Service Bulletin

S.B. No: 139

Title: INSPECTION OF STEERING ARM ON FAIREY HYDRAULICS NOSE LEG

NUMBER 32-16 ISSUE 1

Figure 1 View on top of Nose Landing Gear assembly

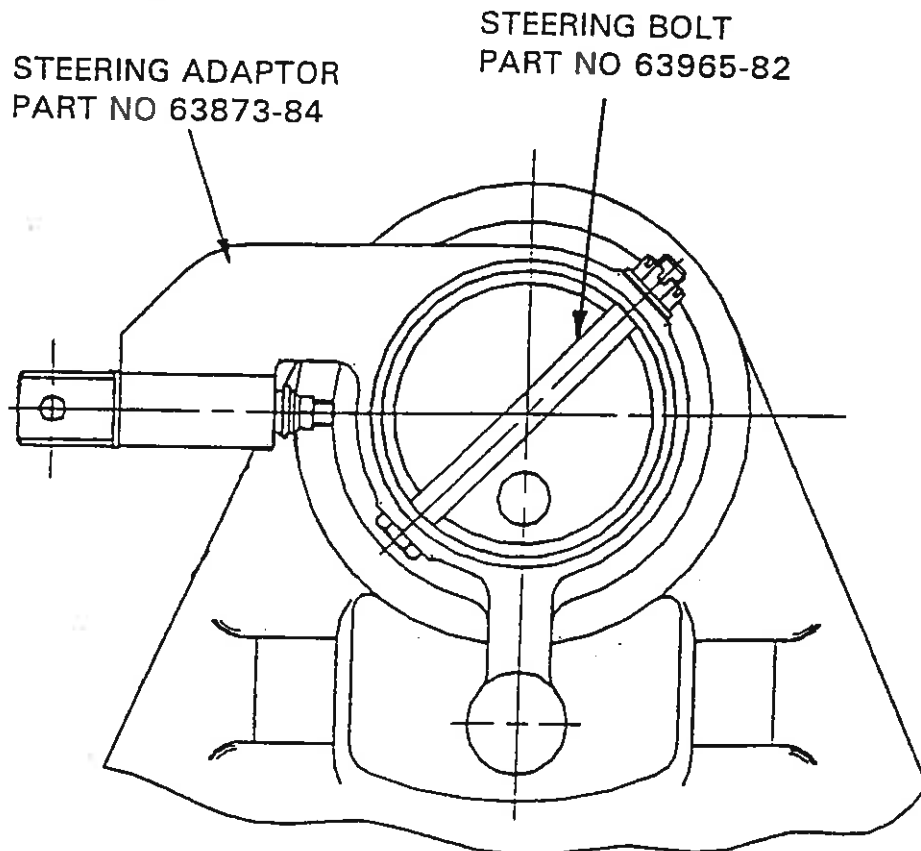
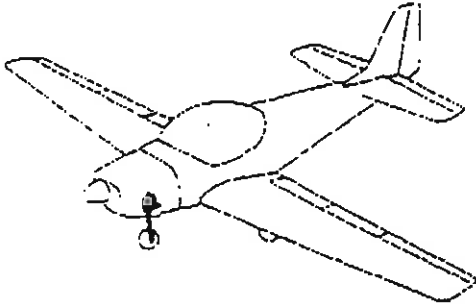
There have been occurrences of minor cracks in the steering adaptor in the following areas (Refer Fig.1 and 2)

- the fillet which joins the integral steering arm and the location ring of the adaptor
- radiating from the holes through which the steering bolt passes

Visual inspection of parts on all nose landing gear assemblies in the position indicated in Fig.1 and 2 of this Service Bulletin.

- a. Cracks not exceeding 0.2 in (5.08 mm)

- (1) Refit parts and Nose Landing Gear Assembly to the aircraft in accordance with the Aircraft Maintenance Manual.

- (2) Repeat inspection every 25 flying hours.

- b. Cracks exceeding 0.2 in (5.08 mm)

- (1) Return defective parts to Fairey Hydraulics Ltd.

- (2) Fit new steering adaptor (Part No 63873-84) and steering bolt (Part No 63965-82).
